Review of Hydrologic Impacts Of the Proposed Stibnite Gold Project Draft Environmental Impact Statement (DEIS) August 2020

September 26, 2020

Prepared by
Robert H. Prucha, Phd, PE
Integrated Hydro Systems, LLC
Boulder, Colorado

Figure 1. SGP Modeling Process and Analysis Tools (B&C, 2018 Existing Conditions Study)

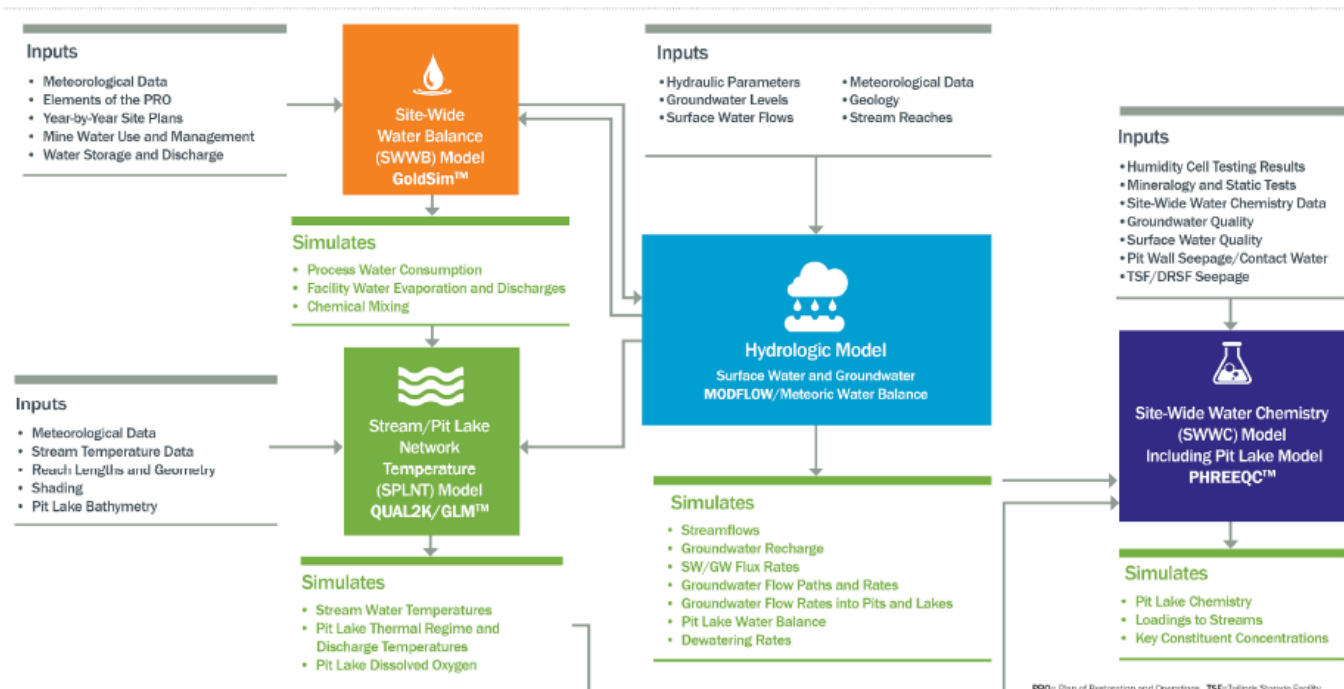
A general 'industry-standard' approach for developing and applying appropriate models to assess hydrologic impacts is lacking in the DEIS, despite B&C presenting a general flow chart (Figure 1) showing how model inputs and outputs are shared across all tools used to assess existing and mine-impacted conditions. A general modeling approach used to develop predictions via use of numerical models was never presented. For my assessment, I reviewed all relevant hydro-related DEIS documents for deficiencies/problems following various modeling steps following the industry standard modeling approach provided by Wels, 2012⁶ (see Figure 2 **Error! Reference source not found.**).

Figure 3. Figure 2 from App D in 2016 SGP Plan of Restoration and Operations, page D-8.

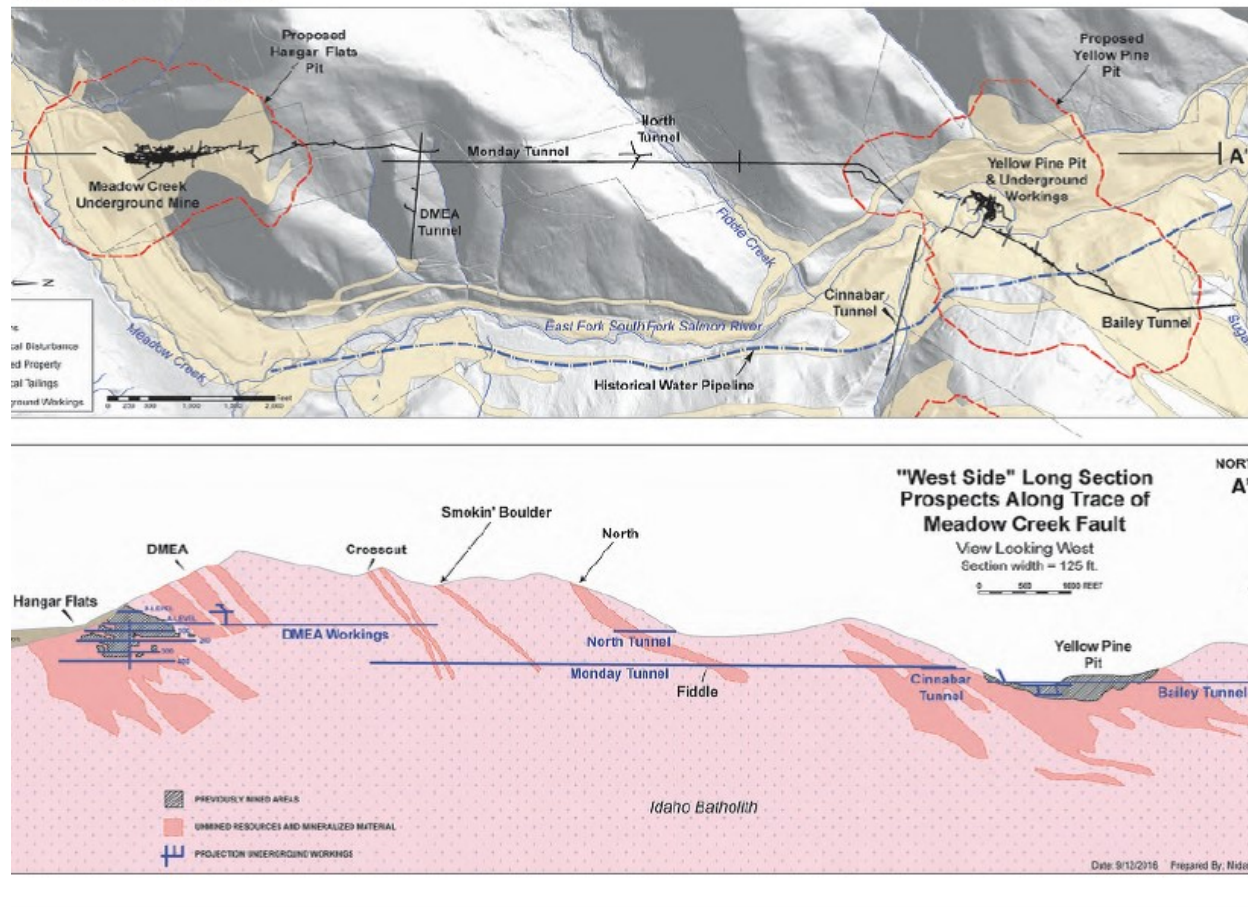
The Plan of Restoration and Operation – Appendix D (2016 SGP Plan of Restoration and Operations, page D-8) shows a cross-section (Figure 2) on Figure 3. This figure indicates substantial underground workings and interconnected tunnels extending from higher elevation

Figure 4. Figure 9-1 from B&C 2017 SGP Water Resources Summary report.

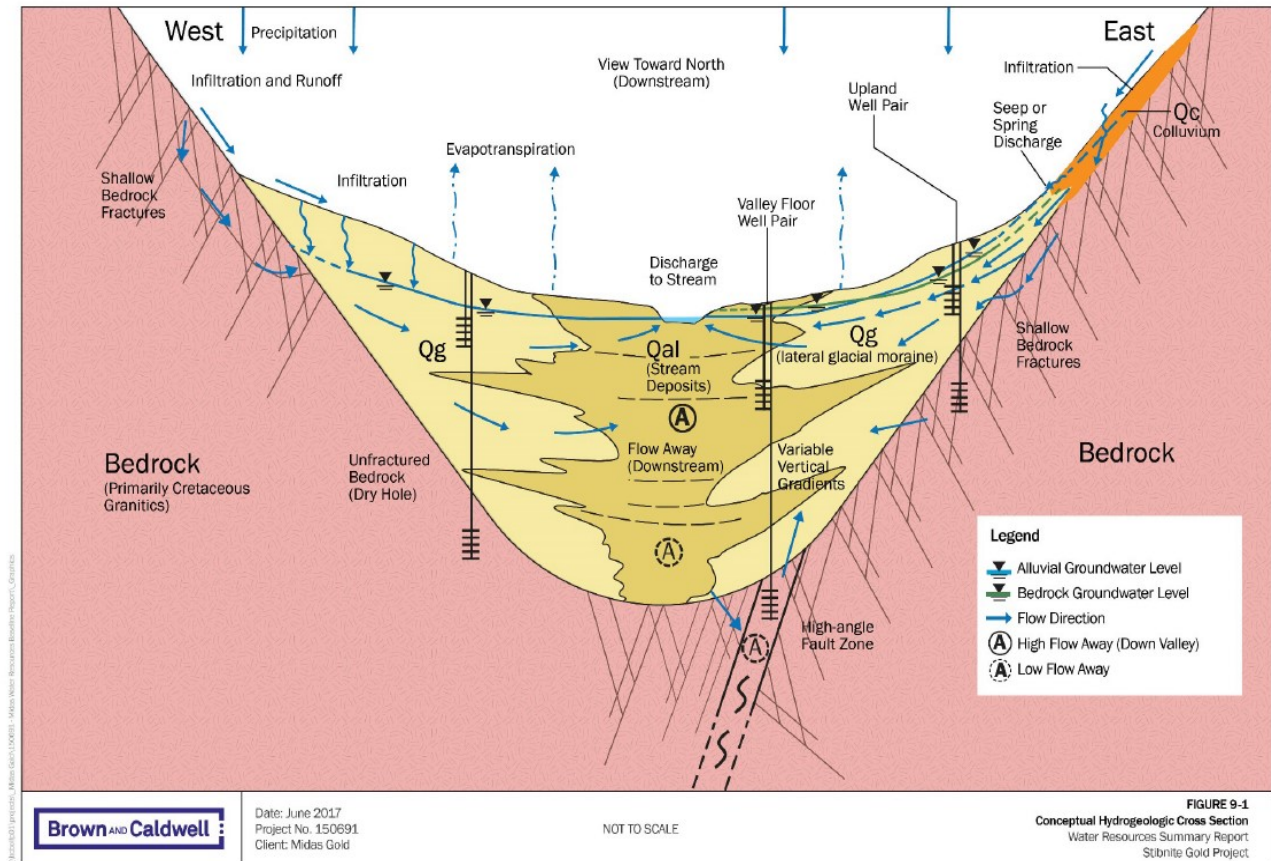
- Another example is that upland areas shown on the conceptual 2D section show shallow bedrock fractures, yet the EC model assumes that bedrock is fractured (and therefore more permeable) only beneath all streams, and arbitrarily assumed to be 500 ft thick.
- Within the thicker valley fill areas (i.e., Meadow Creek near Hangar Flats), even surficial geologic mapping shows Qal stream alluvium embedded within broader Glacial Deposits (Qg), where Qal exhibits greater silts, or lower permeabilities (at least vertically). Yet the EC model lumps the entire 'overburden' into a single layer. Further, the EC model fails to consider hydraulic property variations, such as between Qc (colluvium) and adjacent Qg materials, where their conceptualization shows seeps/springs occur.

Figure 4 (Figure 9-1 from B&C 2017 SGP Water Resources Summary report, page 9-3) indicates the flow conceptualization exhibits some flaws:

- Why is ET only shown in valley sediment? It also occurs on hillslopes and is not insignificant.
- Given the high degree of complexity in the subsurface over the mine footprint, a realistic range of alternative conceptual models should have been considered in the modeling to account for substantial uncertainty in virtually all model input. Conceptual model uncertainty typically accounts for most uncertainty in subsequent numerical model predictions. Neuman and Weiranga, 2003⁹ describe in detail how to incorporate alternative conceptual models into formal uncertainty analyses. Typically, conceptual model uncertainty dominates overall predictive uncertainty and as such should have been more fully assessed in the DEIS modeling evaluations.

Figure 6. Generalized Subsurface Layering and Hydraulic Property Zones in B&C 2018 Existing Conditions modeling study.

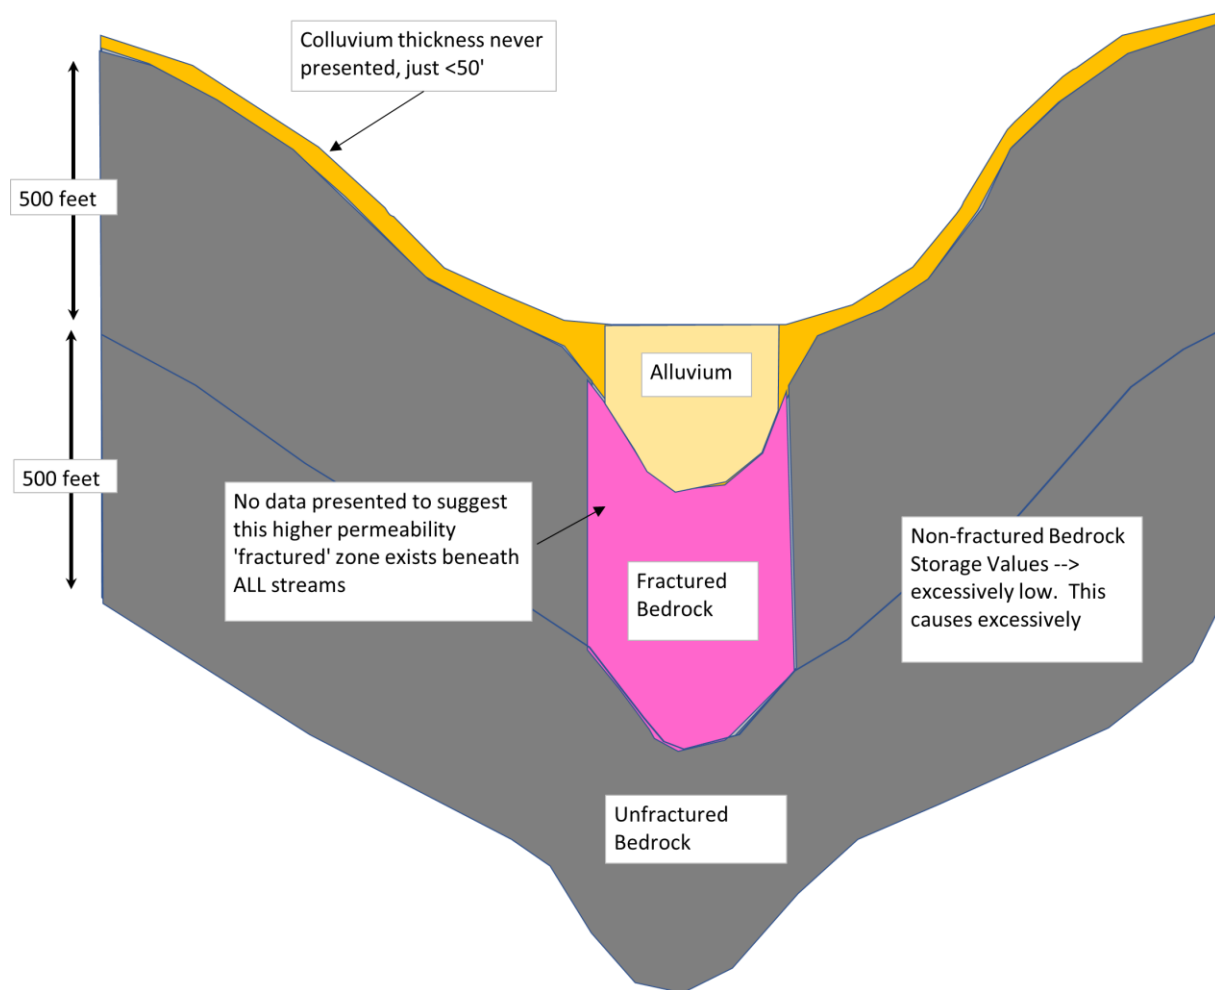
- Figure 6 shows relatively high K specified in bedrock below ALL stream areas within the model. This is very unrealistic and no justification or data provided to support this specification.
- Storage coefficient – 1×10^{-7} 1/ft is incorrect (Table 4-2 in B&C 2018 EC model study), and should instead be a very low number. B&C 2018 EC digital MODFLOW model file inputs indicates it is actually specified as 1×10^{-7} 1/ft. However, this number still appears to be unrealistically low by 1 to 2 orders of magnitude. **A key issue with specifying such a low storage number, is that it directly and notably affects estimated mine impacts, such as total pit dewatering/pitlake fill rates and times, timing/magnitude of impacts to wetlands/streams/GDEs, RIB performance etc.**

Figure 8. B&C 2018 EC Model SFR Stream Leakage (ft³/d) at 5/1/2012. Red areas show losing stream segments, while blue cells indicate streams are gaining.

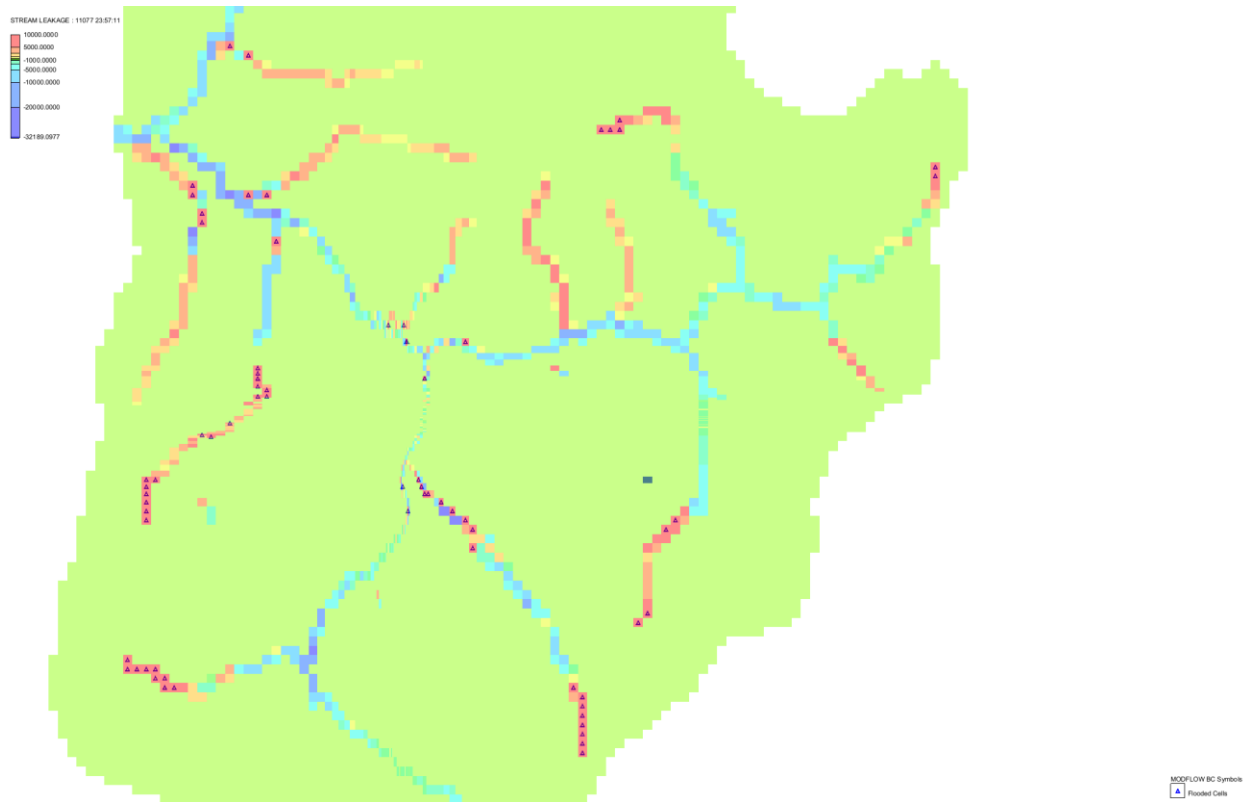
- The 2018 B&C EC study appears to use the USGS MODFLOW SFR2 Stream Routing Package SFR2²², though review of digital model input files shows that neither unsaturated zone flow conditions beneath the streams, nor calculation of dynamics stage (even at monthly time-step) using streambed slope, cross-sectional shape (widths), and hydraulic properties were not utilized. At a minimum, cross-sectional areas should have been specified from available topographic data, both in existing conditions and more importantly in proposed modifications, especially post-closure, when numerous stream segments are re-engineered (i.e., above the TSF/DRSF, and through Hangar Flats and West End pitlakes. This would have better simulated actual flows within streams and flow exchange between stream-aquifer. It would likely also affect stream-temperature predictions.

- Streambed conductance values are important/sensitive controls on the rate of flow exchange between the groundwater and surface water in streams. Yet B&C authors failed to report the final calibrated spatial distribution of these values, and the basis for determining these values (i.e., from field data/characterization) and later modified through the process of calibration. Standard practice in modeling requires transparently disclosing such critical modeling information.

Figure 9. Proposed restoration area of Blowout Creek. Green lines represent Meadow Creek Fault Zone.

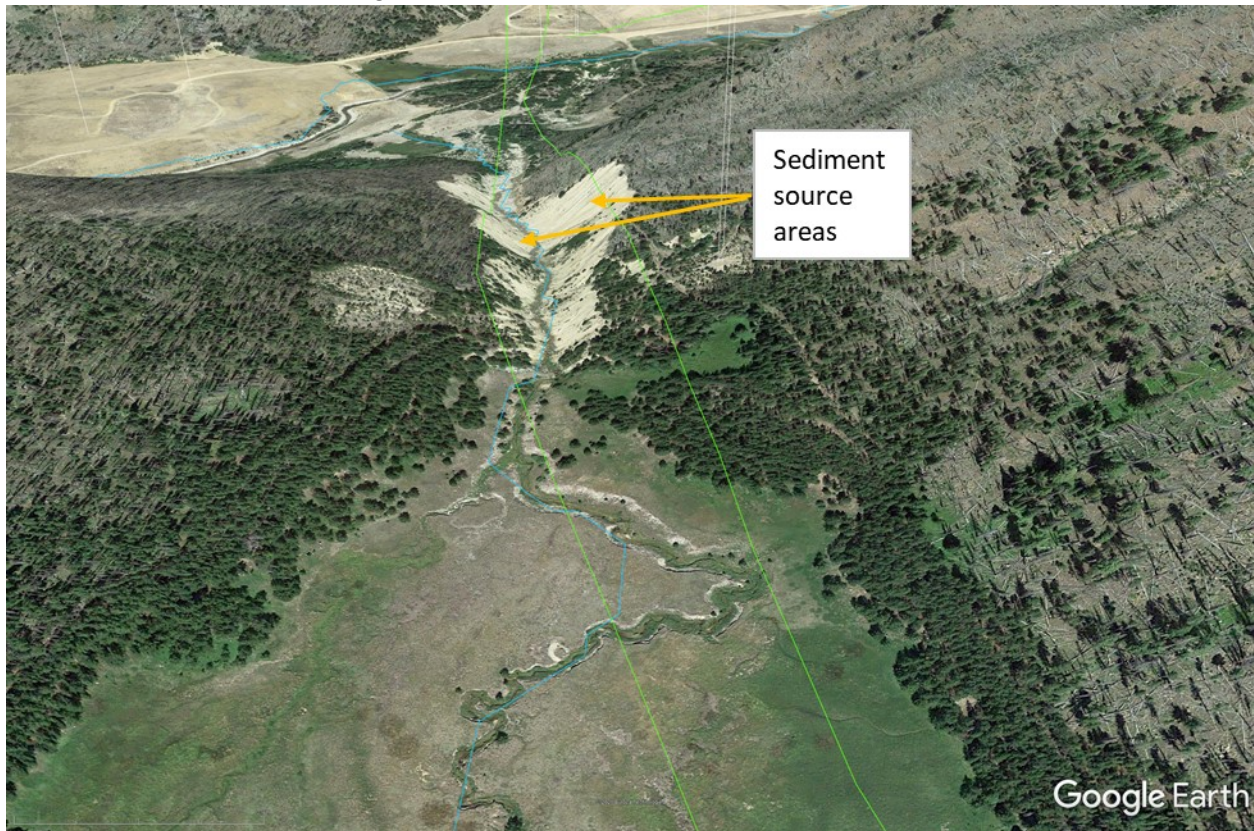
- Visual examination of this area in Google Earth (see Figure 9) strongly suggests the main source of sediment are the exposed sides of the drainage as shown, which are generating rills/gullies. In addition, these appear to be bounded by the trace of the Meadow Creek Fault Zone (two green lines mapped by Stewart et al, 2016¹⁶).

- include surface water diversions above upper top of slopes along exposed slopes to account for future post-fire flooding in the area, which would only further degrade the area.
